ADDENDUM 9

Miami Lakes Library Branch

EXTERIOR IMPROVEMENTS AND COMPREHENSIVE INTERIOR RENOVATIONS

14-JUL-2025

DF

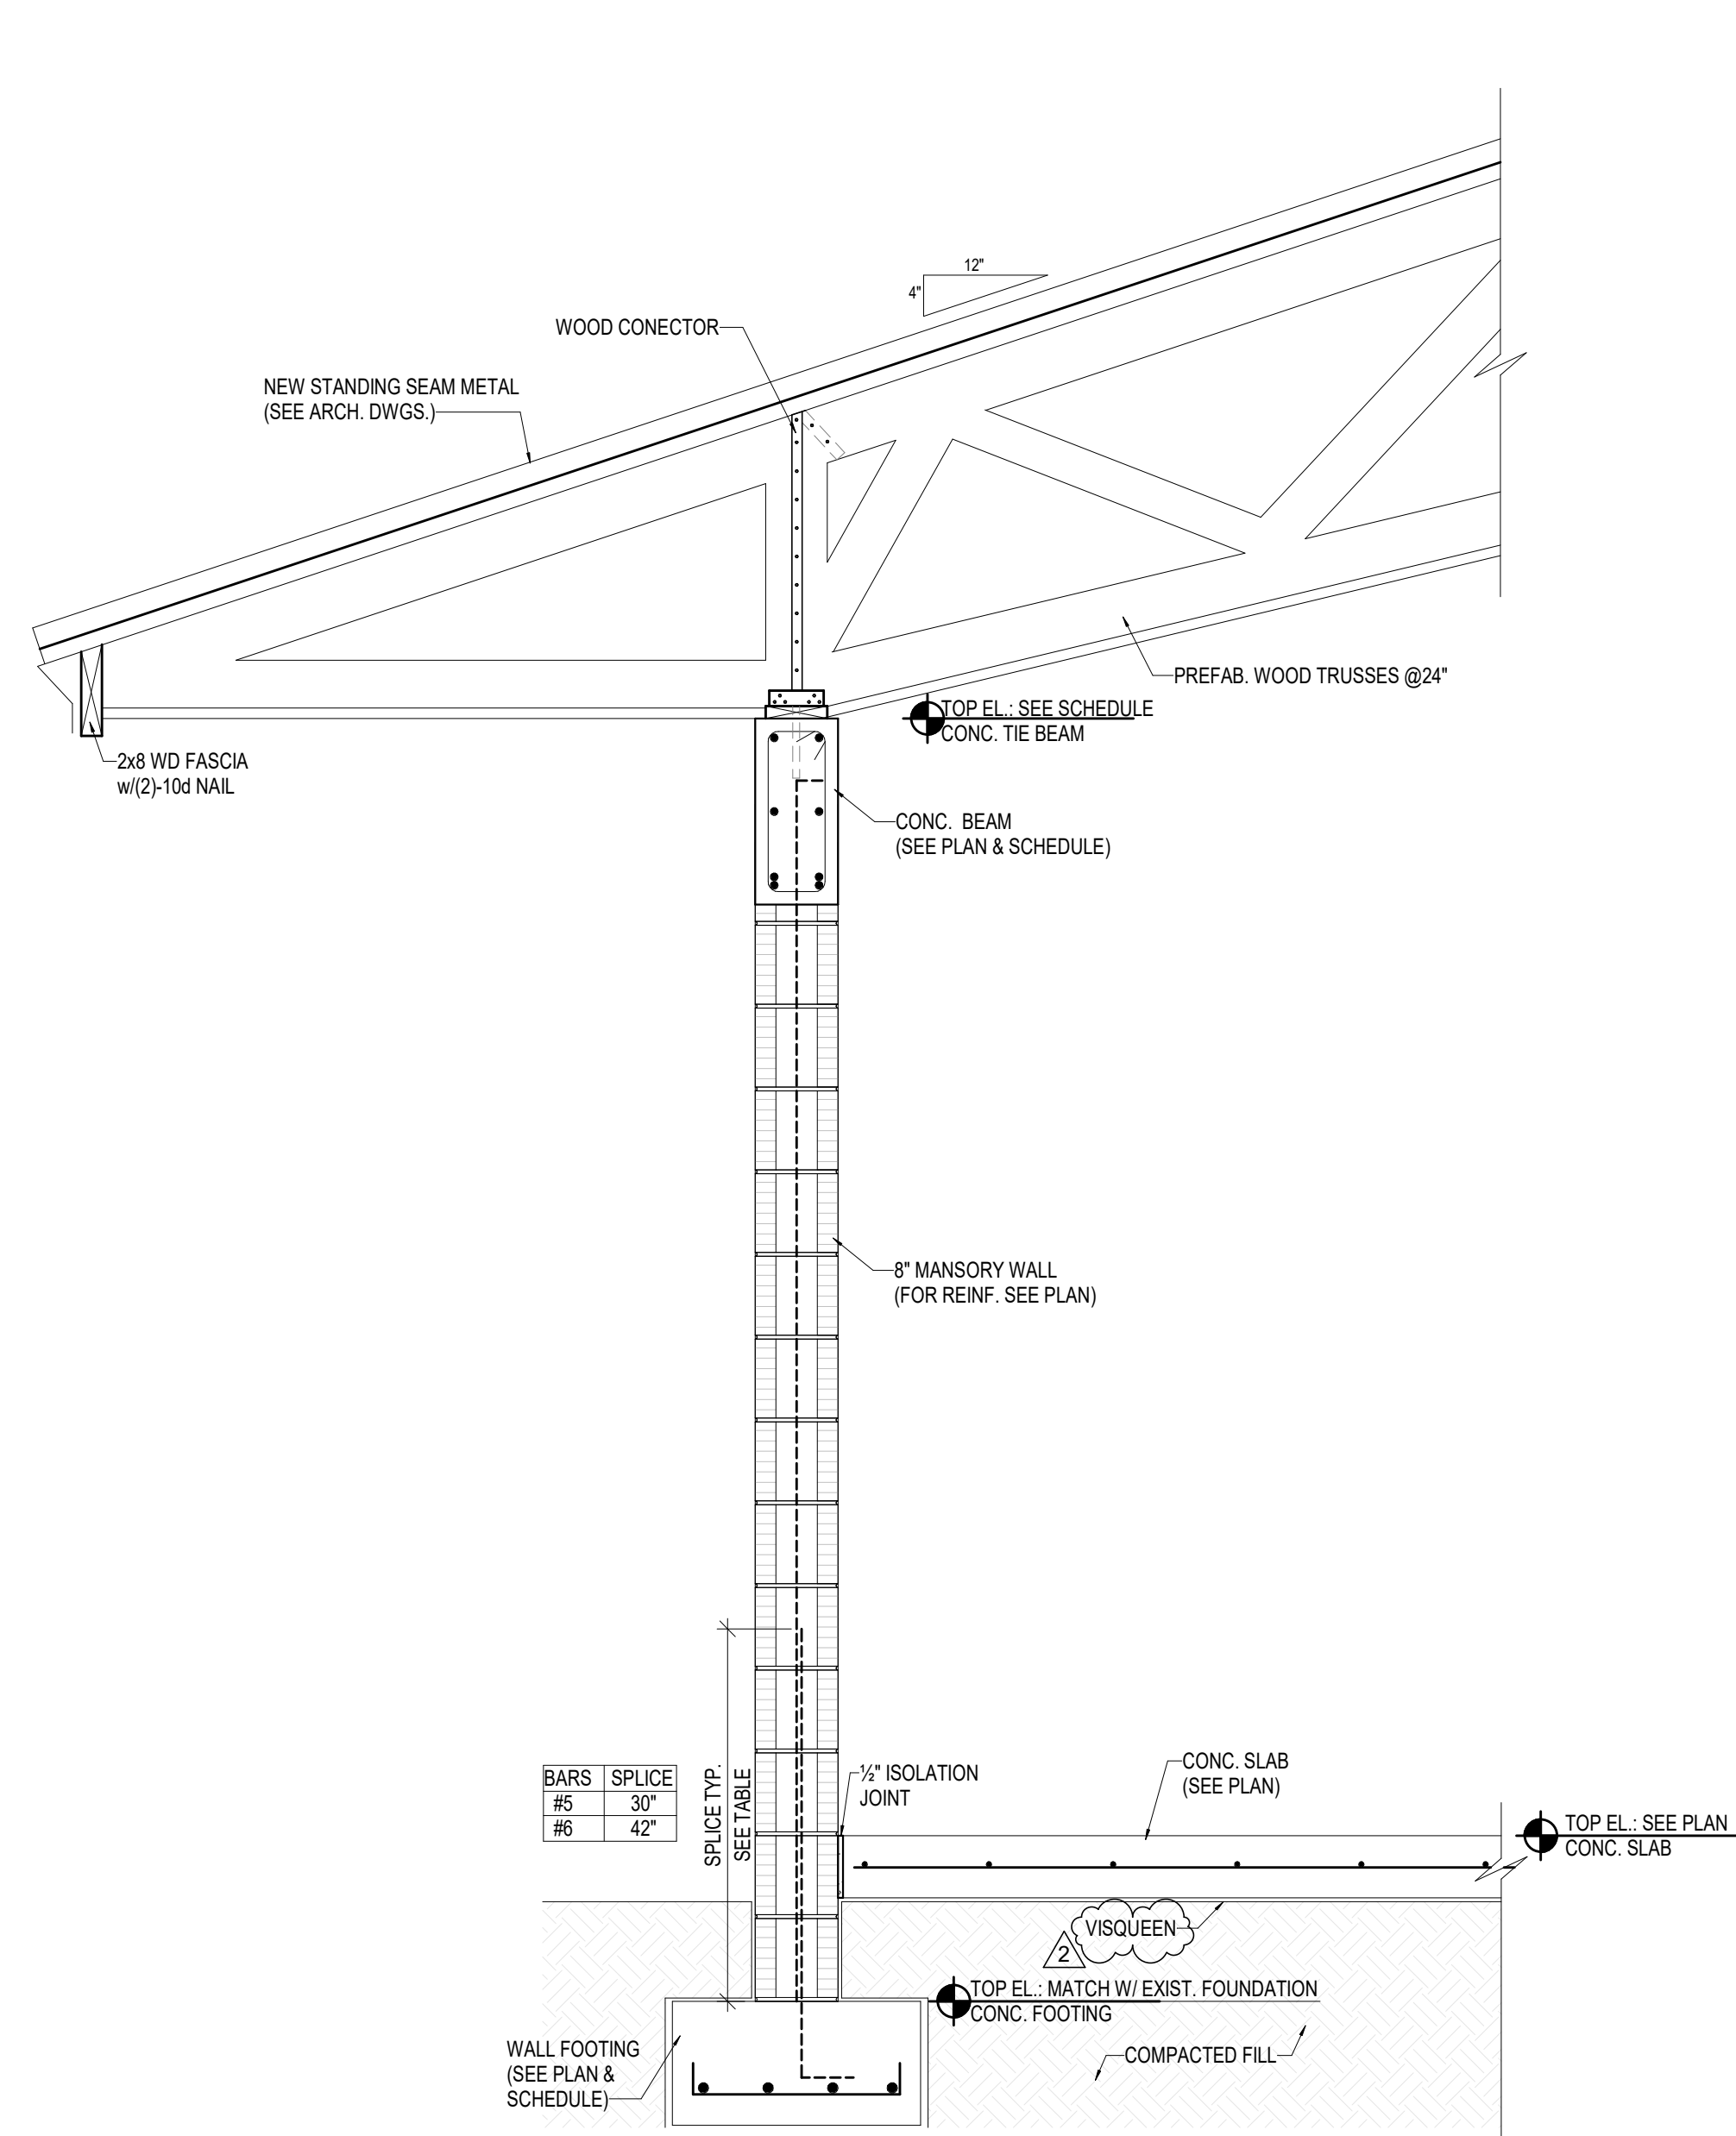
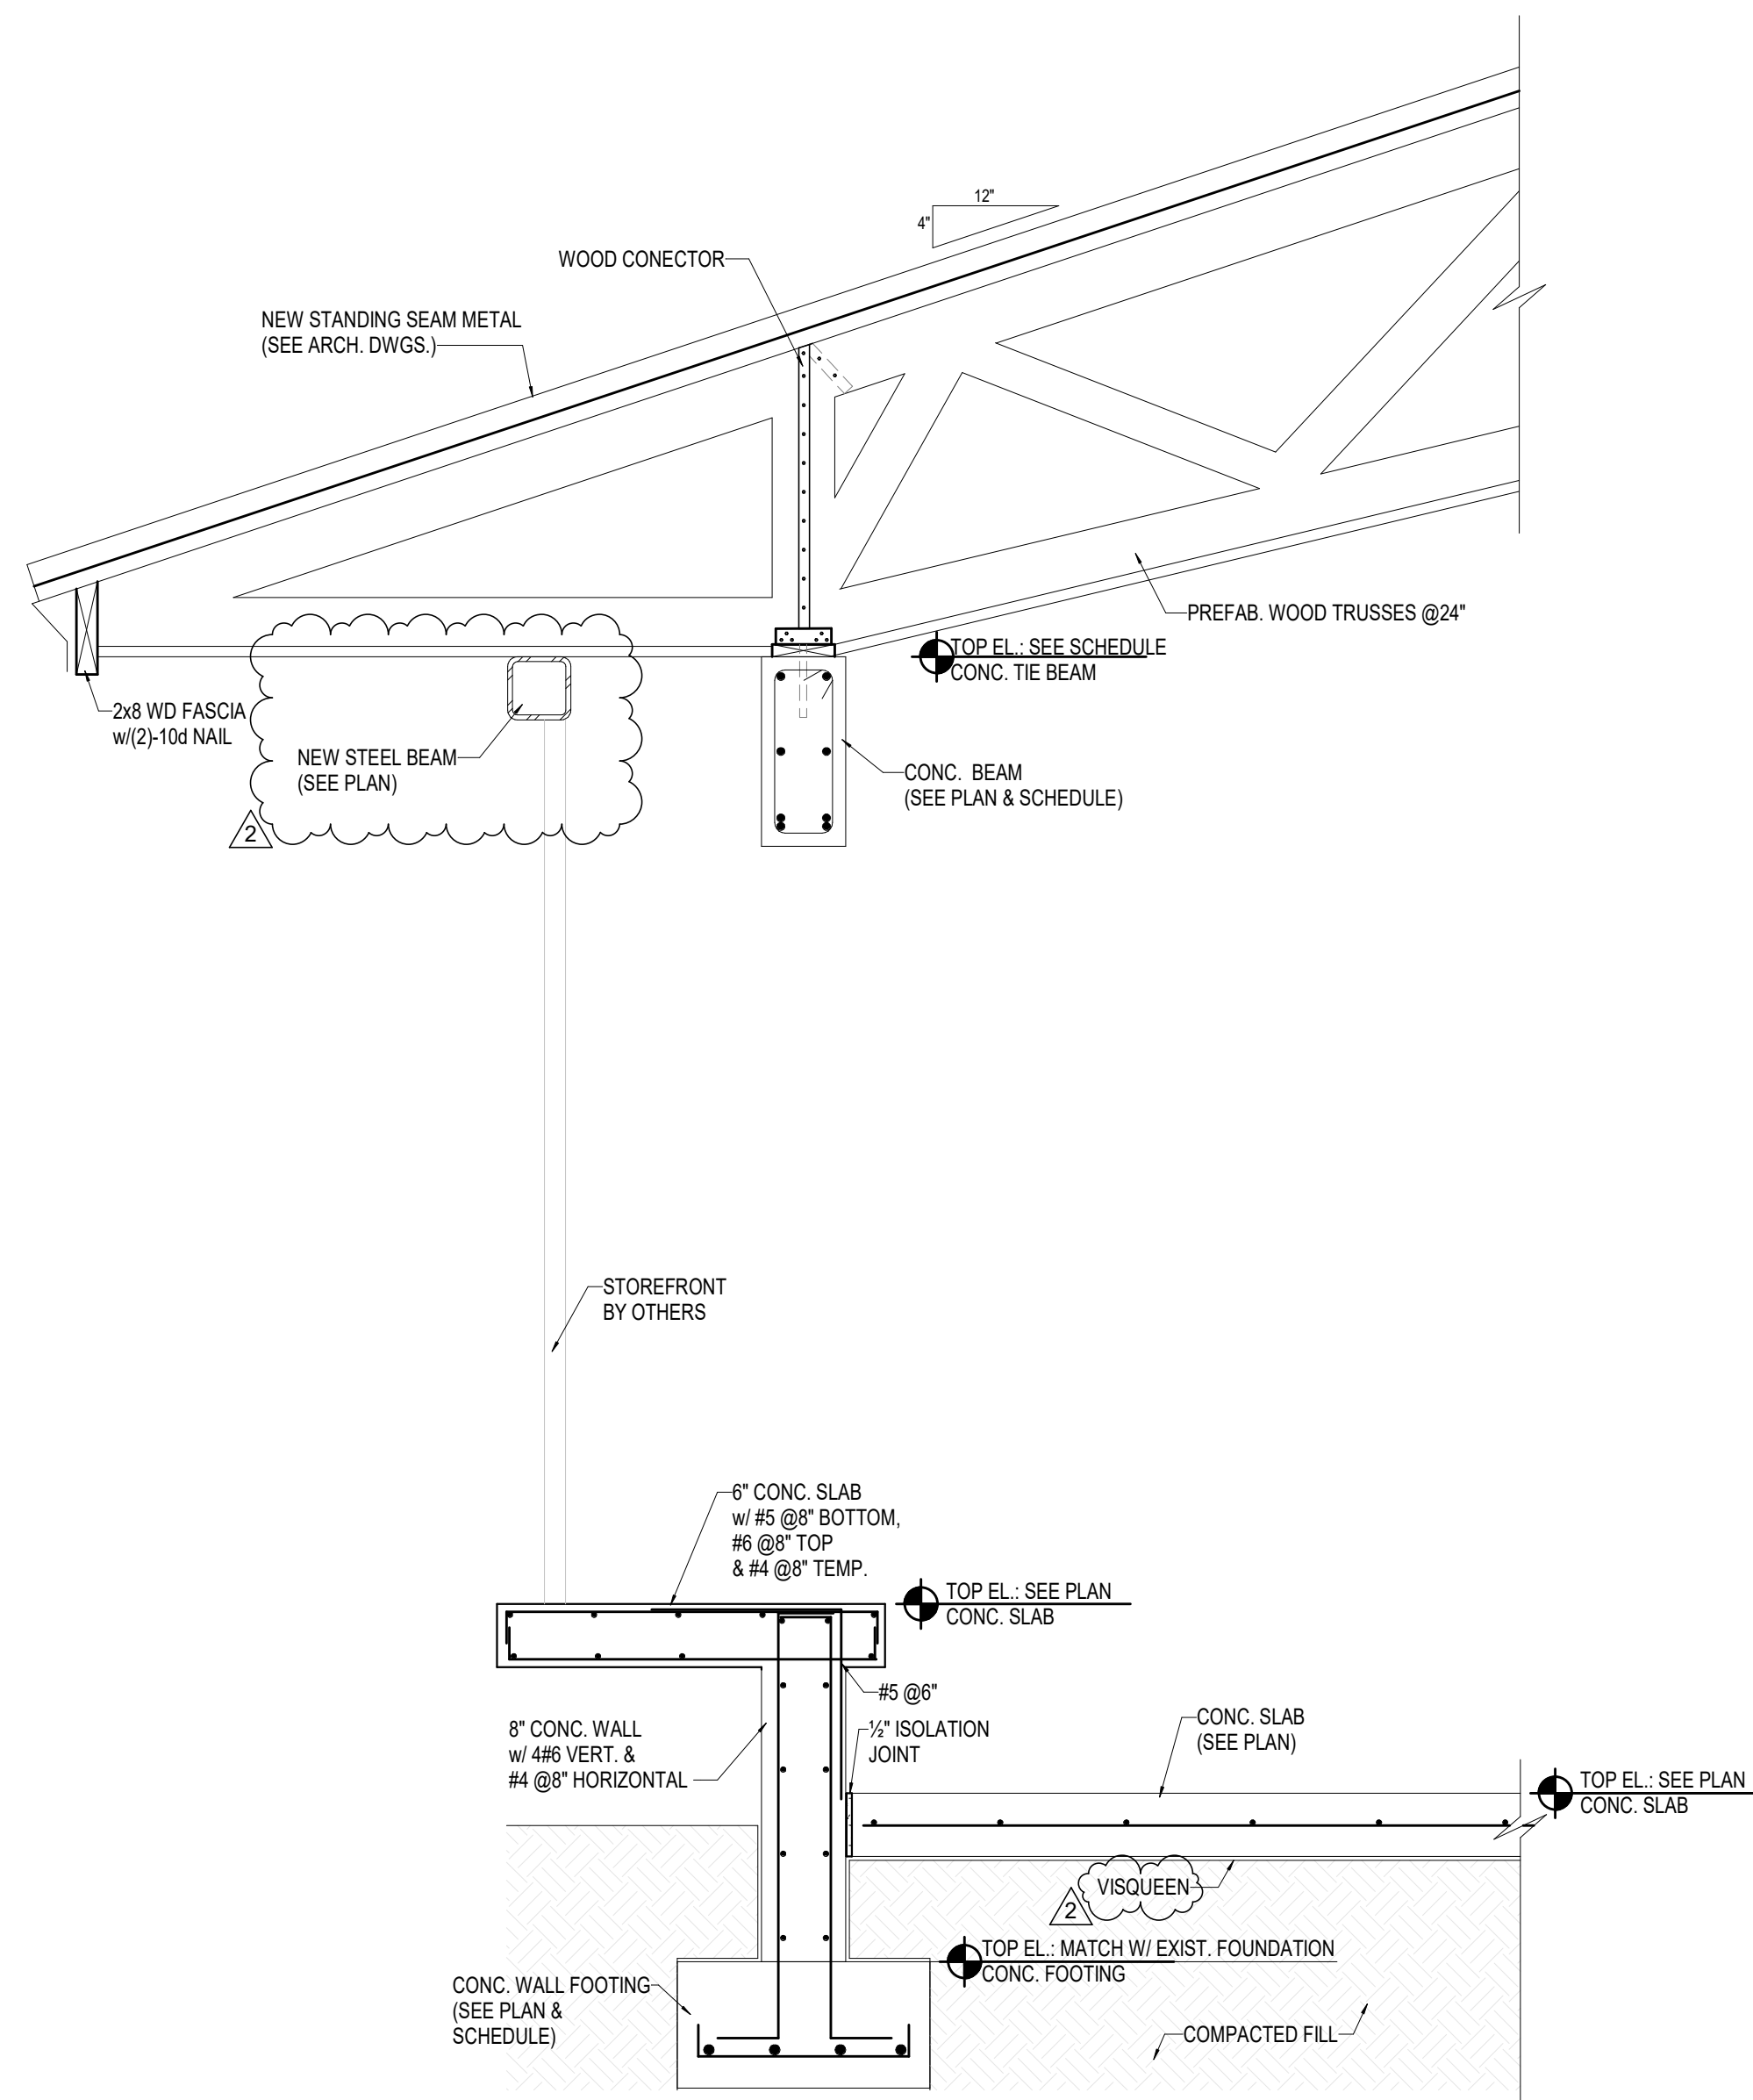
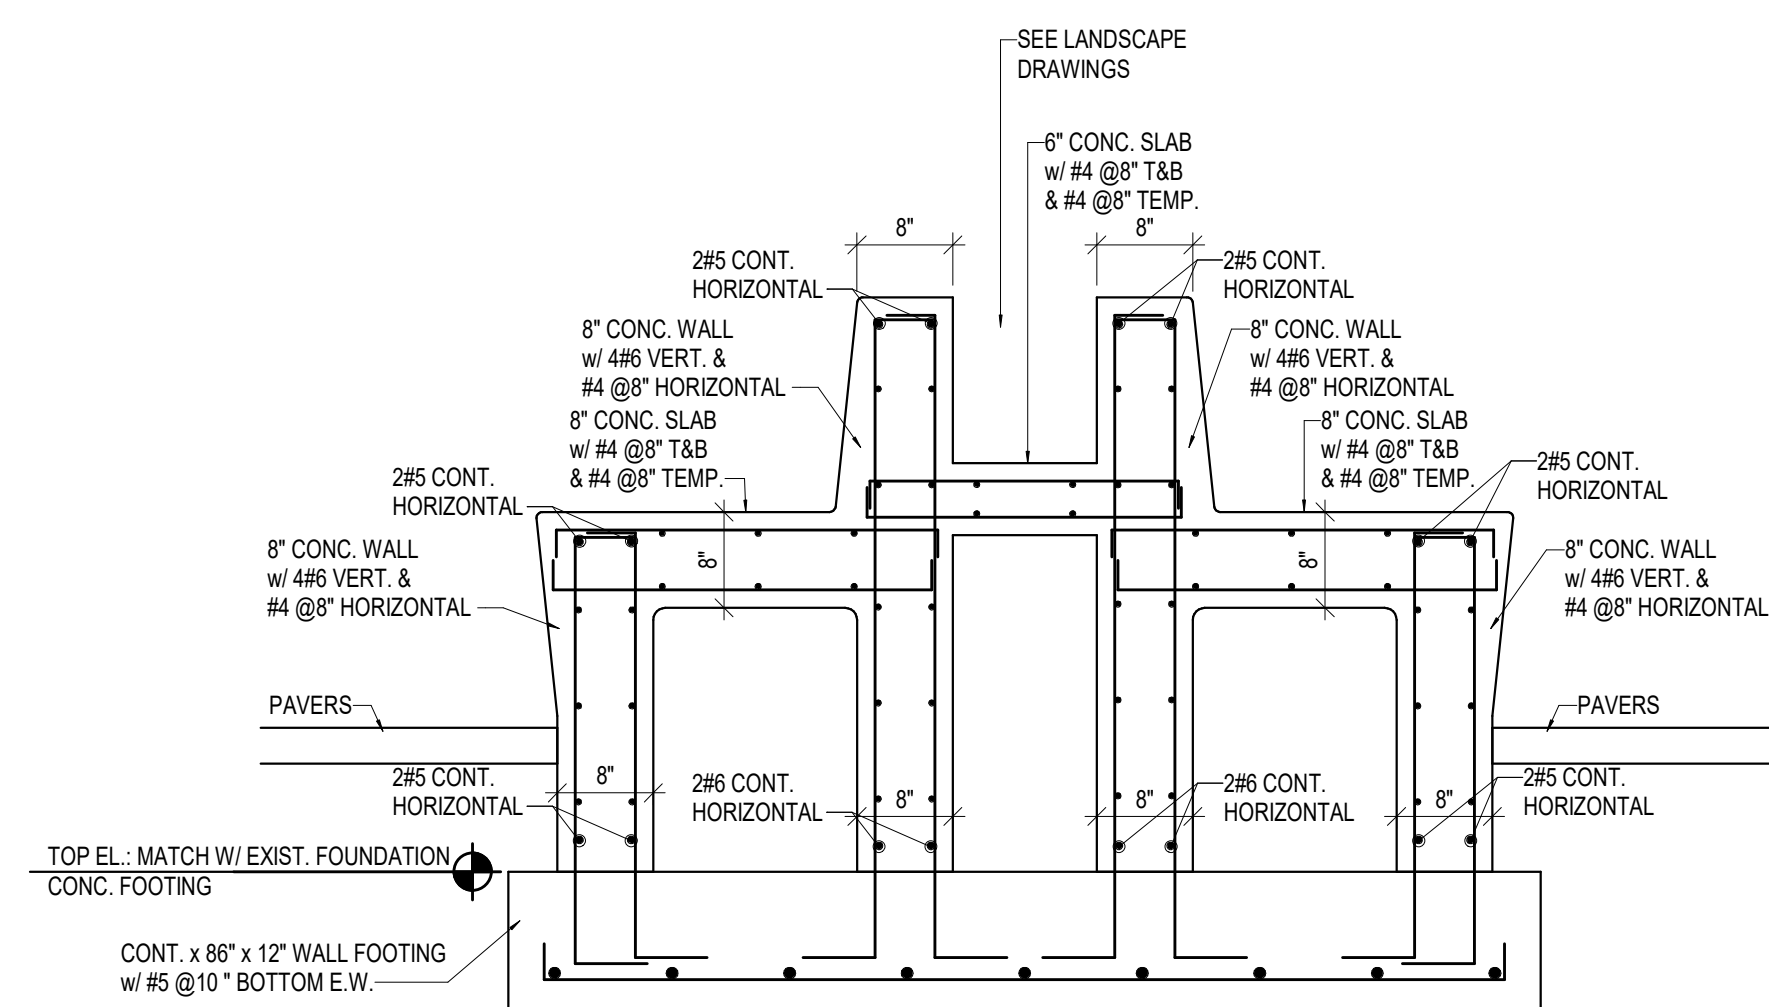
Q191. Plan Sheet S302 showing sections 4/S302 and 6/S302 do not show the steel beam required at the storefront on the corner window seats. Please add steel beams or notes regarding the structural steel columns and beams at the window seats.

A191. *The steel beams and columns are noted on Sheet S102. The steel beams above have been added to the sections on S302 and S303. All other required elements shall be included in the storefront shop drawings. GC to provide engineered shop drawings for review and approval.*
